CITY OF GLENDALE, CA

ADMINISTRATIVE DESIGN REVIEW STAFF REPORT – MULTI-FAMILY

1037 Ruberta Avenue

PDR2115117

WINDOW SECTION

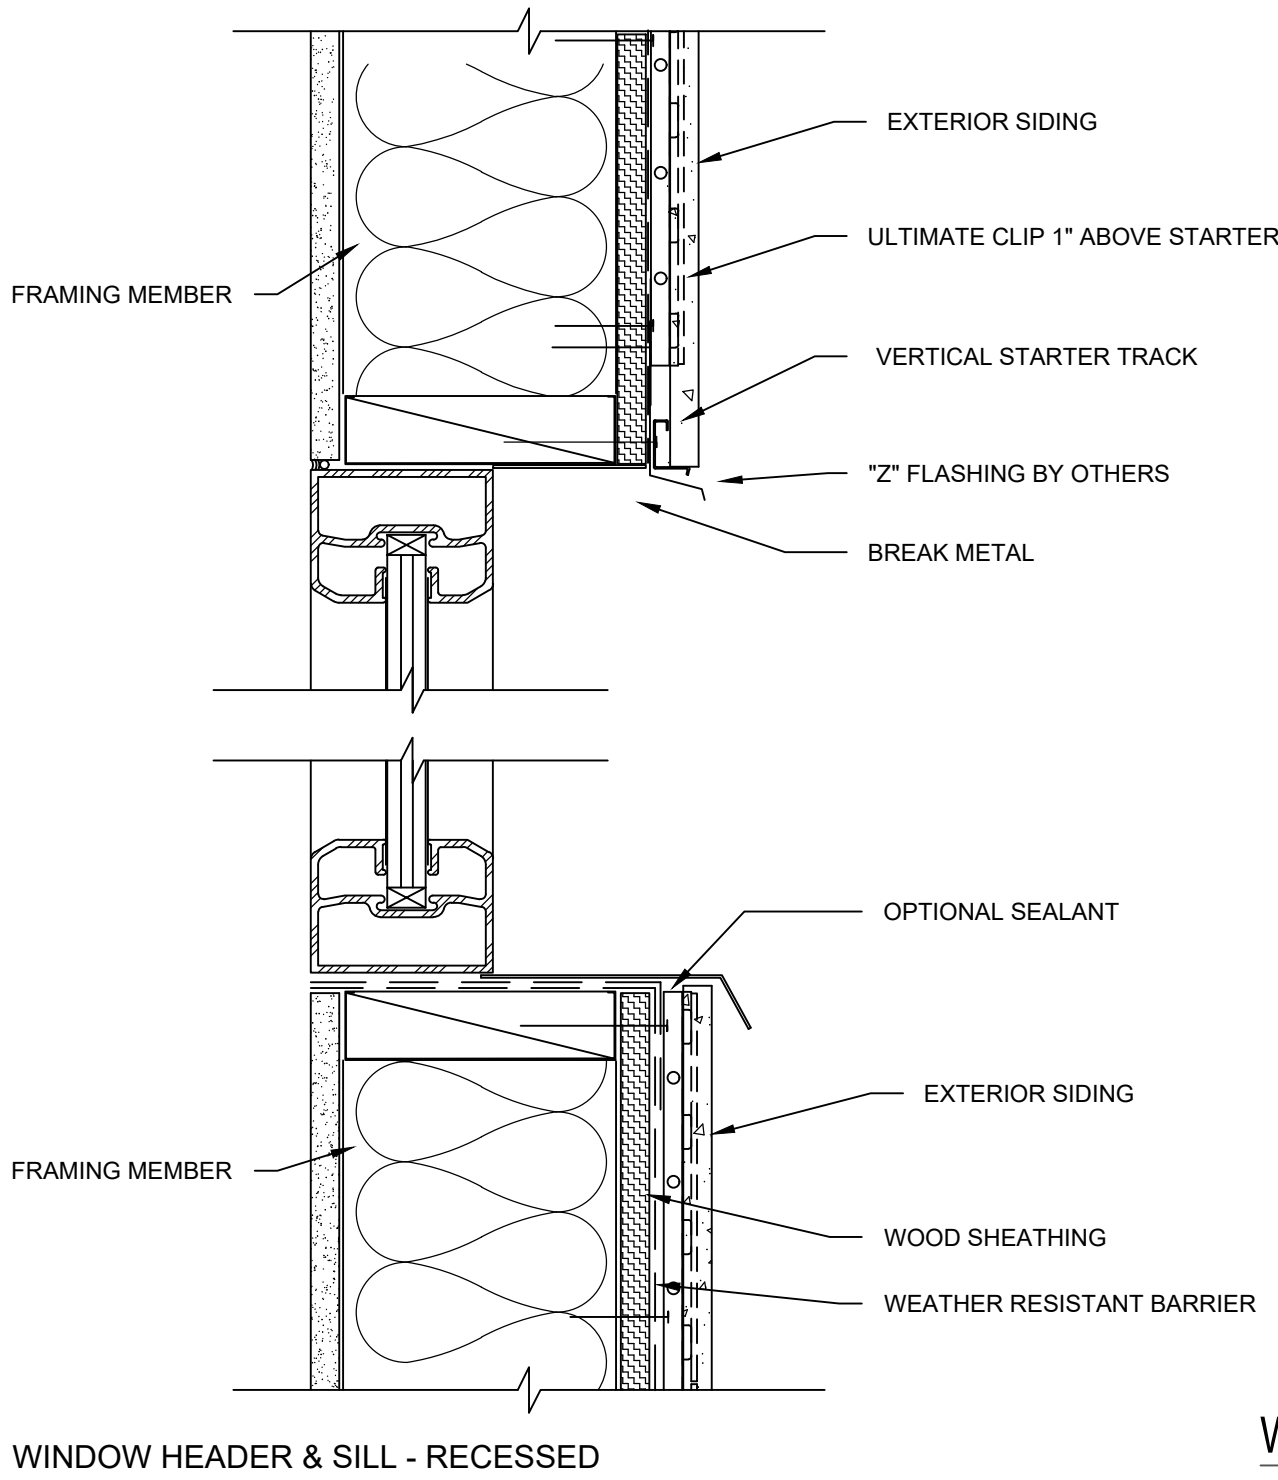
1. Clarify that the posts/gate are located behind building façade of Unit A.
2. Revise vertical window section detail to show sills and trim.
3. Restudy window grid patterns and provide revised drawings for staff review prior to submittal.
4. Provide information and details for: proposed railings, gate, driveway gate, posts, light fixtures on the material board or provide call-outs for all exterior material on elevations.
5. Exterior cladding material to wrap at interior corners of Unit A on north and east elevations.
